LANDMARK COMMISSION

FILE NUMBER: COA-26-000306
LOCATION: 1240 Washington St
STRUCTURE: Contributing
COUNCIL DISTRICT: 7
ZONING: CR, CS, IM, MC-1, MF-2(A),
NS(A), PD-288

1. A Certificate of Appropriateness to construct a new accessory structure in the left (west) side yard of the main building -- a freestanding, metal carport.
2. A Certificate of Appropriateness to install an eight-foot-high (8') screened perimeter fence with a sliding gate (to obscure the proposed carport).

FRONT VIEW (FROM STREET LOOKING AT STRUCTURE)

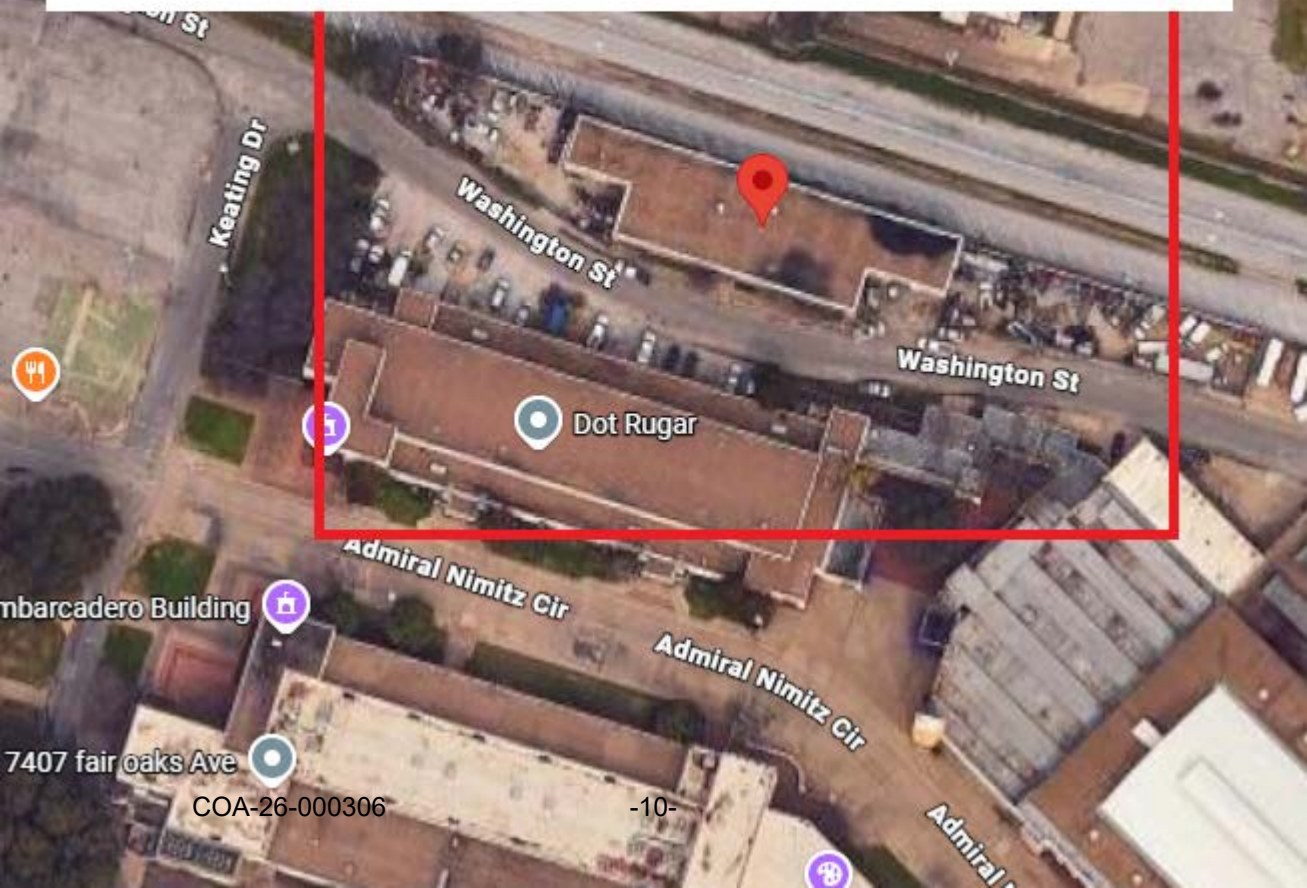
- Structure is set in the ground with 3" steel posts.
- Structure height (7'-9") is below fence height (8'-0").

**STRUCTURE HEIGHT: 7'-9" (93")
BELOW FENCE LINE**

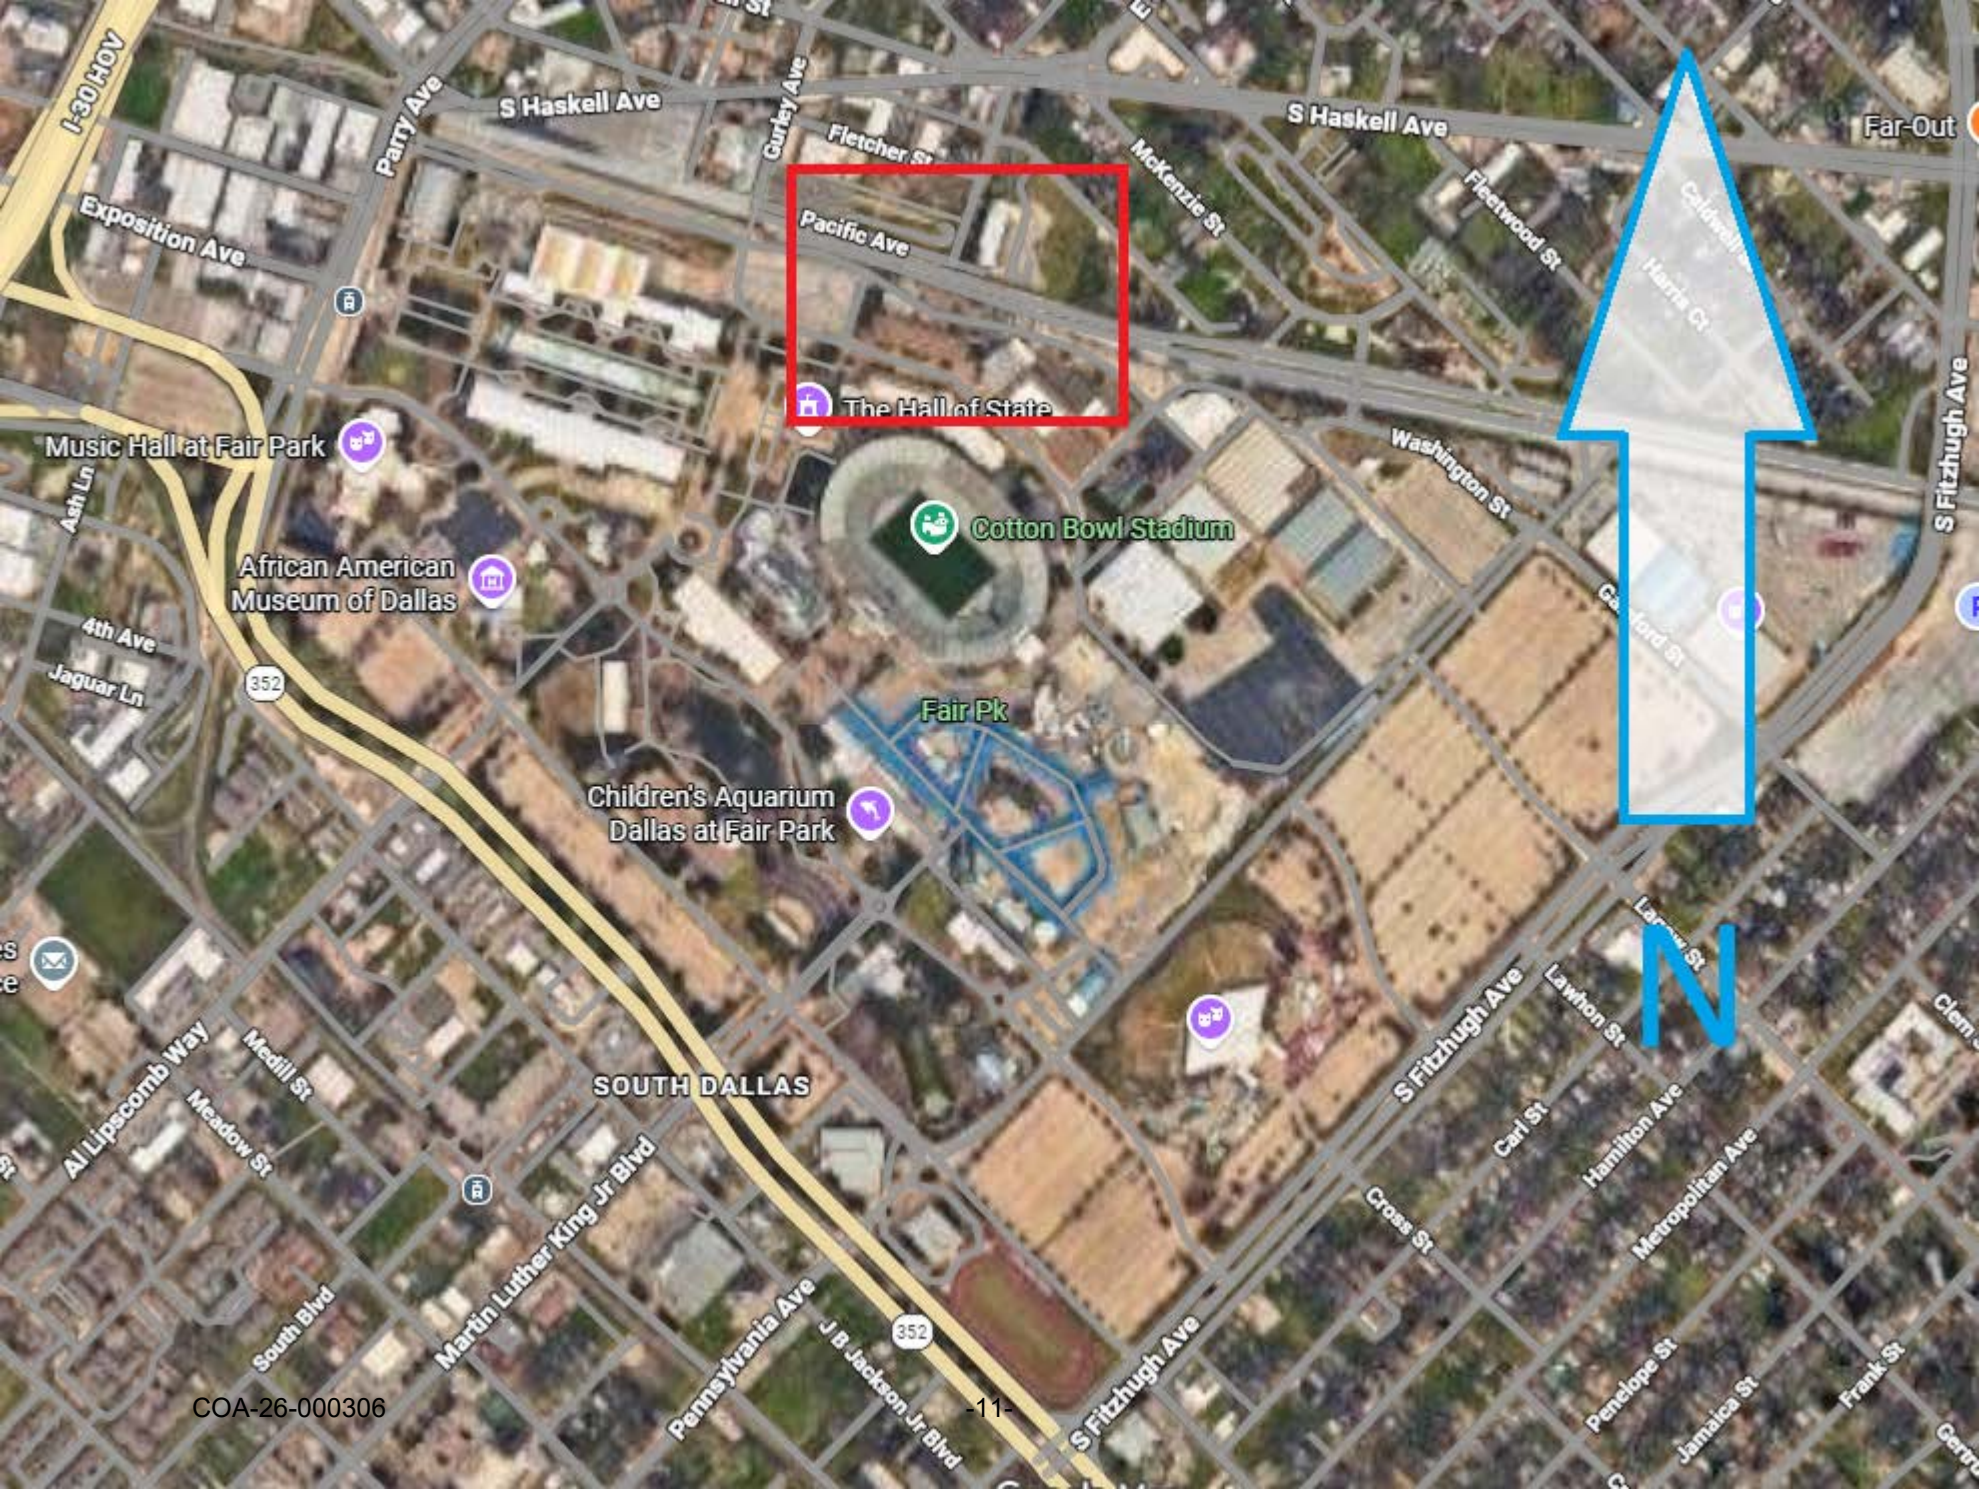
Lock up structure to be below fence line and not touch any existing building.

These gates swing out

Fence will slide vs swinging out

Below fence line
and will provide better security for
equipment.
